# Final Development Plan Report – Comments Responses

For: *The Eastside Development and Hangar 2 at*  
**LEE'S SUMMIT MUNICIPAL AIRPORT**  
LEE'S SUMMIT, MO

November 13, 2023

## **CMT Responses to Planning and Development Review Comments**

## **APPENDIX D – EAST ELEVATION METAL PANEL AREA**

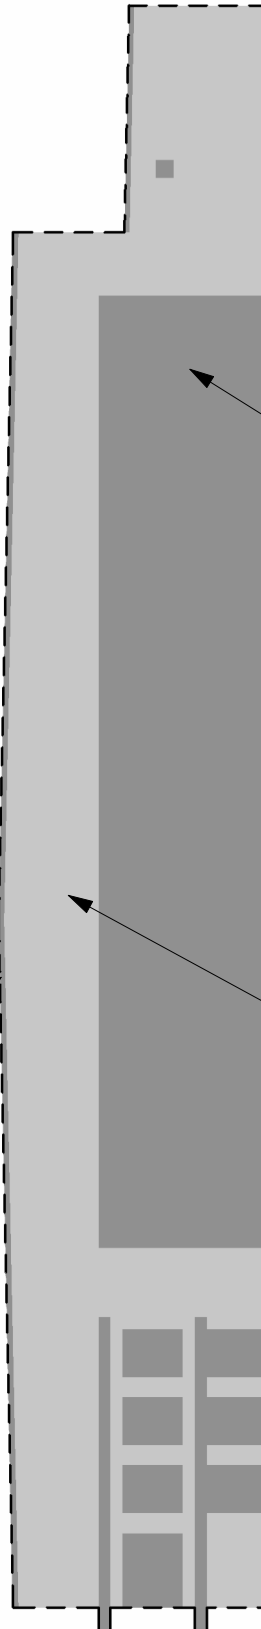
6. APPROVED MATERIALS. Quantify the percentage of approved materials (i.e. rough-textured metal panel and glazing) used on the east elevation to check for compliance of the minimum 50% approved materials requirement for the front of the building.

Acknowledged. Refer to drawing in Appendix D of the east elevation that shows that over 50% of the east elevation is comprised of approved materials listed in Section 8.170 subsection A including textured metal panel per building material legend.

- THE TOTAL AREA OF THE EAST ELEVATION IS 10,848 SQFT.
- THE AREA OF THE METAL PANEL IS 5,351 SQFT.
- THE COMBINED AREAS OF TEXTURED MTL PANEL, FASCIA, TRIM, GLAZING SYSTEMS, AND LOUVERS IS 5,497 SQFT.
- THE APPROVED MATERIALS AREA IS 146 SQFT. MORE THAN THE REQUIRED MINIMUM

TOTAL AREA OF EAST ELEVATION: 10,848 SQFT

TOTAL AREA METAL PANEL: 5,351 SQFT
